Contract #: 04-0120F4Cty: SF/ALA Rte: 80 PM: 13.2/13.9File #: 69.25B**QUALITY ASSURANCE -- NON-CONFORMANCE REPORT****Location:** Changxing Island, Shanghai, P.R. China**Report No:** NCR-000528**Prime Contractor:** American Bridge/Fluor Enterprises, a JV**Date:** 07-Dec-2009**Submitting Contractor:** Zhenhua Port Machinery Company, Ltd (ZPMC), Changxing Island**NCR #:** ZPMC-0501**Type of problem:**

<b>To:</b>	AMERICAN BRIDGE/FLUOR, A JV 375 BURMA ROAD OAKLAND CA 95607	<b>Date:</b>	24-Dec-2009
<b>Dear:</b>	Mr. Charles Kanapicki	<b>Contract No:</b>	04-0120F4 04-SF-80-13.2 / 13.9
<b>Attention:</b>	Mr. Thomas Nilsson Project/Fabrication Manager	<b>Job Name:</b>	SAS Superstructure
<b>Subject:</b>	NCR No. ZPMC-0501	<b>Document No:</b>	05.03.06-000489

**To:** CALTRANS - SAS Superstructure  
333 Burma Road  
Oakland CA 94607  
**Attention:** Pursell, Gary  
Resident Engineer  
**Ref:** 05.03.06-000489  
**Subject:** NCR No. ZPMC-0501

Contract #: 04-0120F4Cty: SF/ALA Rte: 80 PM: 13.2/13.9File #: xx.25A**QUALITY ASSURANCE -- NON-CONFORMANCE RESOLUTION****Location:** Changxing Island, Shanghai, P.R. China**Report No:** NCS-000461**Prime Contractor:** American Bridge/Fluor Enterprises, a JV

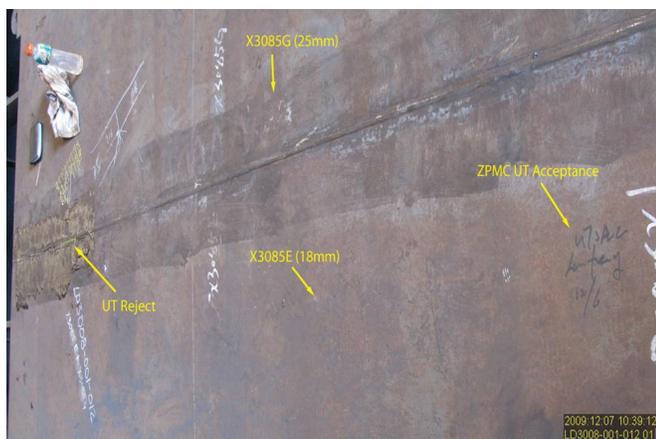
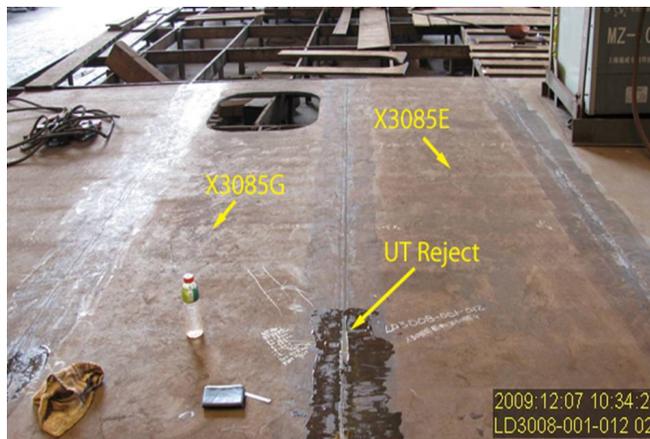
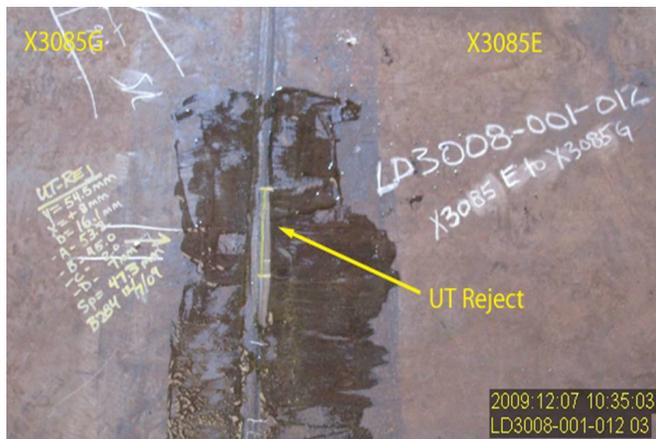
During the Quality Assurance Ultrasonic Testing (UT) review of welds located on Longitudinal Diaphragm LD3008-001, this Quality Assurance Inspector (QA) discovered the following issues:

- One (1) longitudinal indication measuring approximately 100mm in length, a depth of 16.2mm. The dB rating is a +7 and the material thickness is a transition from 18mm to 25mm. For additional information please see the UT report for this date.
- The weld is identified as: LD3008-001-012 for Lift 12.
- The Weld is a Complete Joint Penetration (CJP) butt weld joining the 18mm plate (X3085E), to the 25mm plate (X3085G).
- The member is located in Bay 3.
- The Notice of Witness Inspection Number (NWIT) is 004810. The indication is located inside the area that has been previously tested and accepted by ZPMC Quality Control (QC) personnel. As per the contract documents, ZPMC's QC personnel are required to perform one hundred (100%) percent UT inspection of this weld.

-Special Provisions Section 8.3; "Quality Control (QC) shall be the responsibility of the Contractor. As a minimum, the Contractor shall perform inspection and testing of each weld joint prior to welding, during welding, and after welding as specified in this section and to ensure that materials and workmanship conform to the requirements of the contract documents."

-AWS D1.5 Section 6.26.3.1; "Welds that are subject to UT in addition to visual inspection shall be acceptable if they meet the following requirements:...(1) Welds subject to tensile stress under any condition of loading shall conform to the requirements of Table 6.3...(2) Welds subject to compressive stress shall conform to the requirements of Table 6.4."

**Reference Resolution:** In the presence of the CT inspector, ZPMC ground the surface. The weld was re-UT'd immediately and found to be acceptable. ZPMC requests closure of this NCR.

This "missed indication" was interpreted to be a surface indication. In the presence of the CT inspector, ZPMC ground the surface. The weld was re-UT'd immediately and found to be acceptable. No weld repair was performed, no excessive time lapse during the grinding process. It is difficult to understand why this condition was elevated to an NCR when there was a cooperative relationship involved to quickly solve the problem immediately at the shop floor level. ZPMC requests closure of this NCR.

Inspector confirms minor grinding. This NCR is closed.

Welding  Concrete  Other Welding  Curing  Procedural  Bridge No: 34-0006Joint fit-up  Coating  Other  Component: Lift 12 Longitudinal Diaphragm Weld LD3008-001Procedural  Procedural  Description: Missed UT Indication

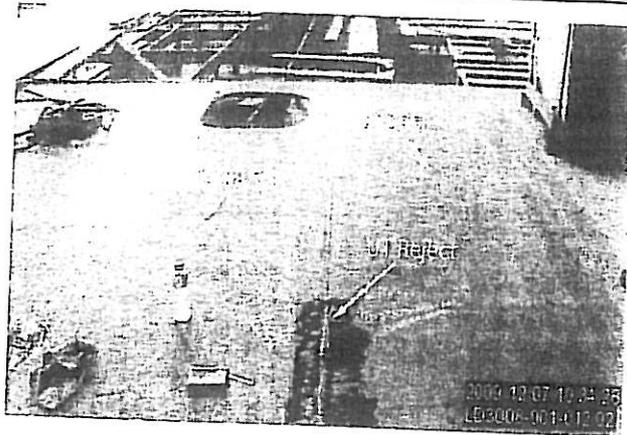
During the Quality Assurance Ultrasonic Testing (UT) review of welds located on Longitudinal Diaphragm LD3008-001, this Quality Assurance Inspector (QA) discovered the following issues:

- One (1) longitudinal indication measuring approximately 100mm in length, a depth of 16.2mm. The dB rating is a +7 and the material thickness is a transition from 18mm to 25mm. For additional information please see the UT report for this date.
- The weld is identified as: LD3008-001-012 for Lift 12.
- The Weld is a Complete Joint Penetration (CJP) butt weld joining the 18mm plate (X3085E), to the 25mm plate (X3085G).
- The member is located in Bay 3.
- The Notice of Witness Inspection Number (NWIT) is 004810. The indication is located inside the area that has been previously tested and accepted by ZPMC Quality Control (QC) personnel. As per the contract documents, ZPMC's QC personnel are required to perform one hundred (100%) percent UT inspection of this weld.

-Special Provisions Section 8.3; "Quality Control (QC) shall be the responsibility of the Contractor. As a minimum, the Contractor shall perform inspection and testing of each weld joint prior to welding, during welding, and after welding as specified in this section and to ensure that materials and workmanship conform to the requirements of the contract documents."

-AWS D1.5 Section 6.26.3.1; "Welds that are subject to UT in addition to visual inspection shall be acceptable if they meet the following requirements:...(1) Welds subject to tensile stress under any condition of loading shall conform to the requirements of Table 6.3...(2) Welds subject to compressive stress shall conform to the requirements of Table 6.4."

Remove indication by grinding.

Indication was removed by grinding. Magnetic Particle Testing was performed to verify the indication was removed completely.
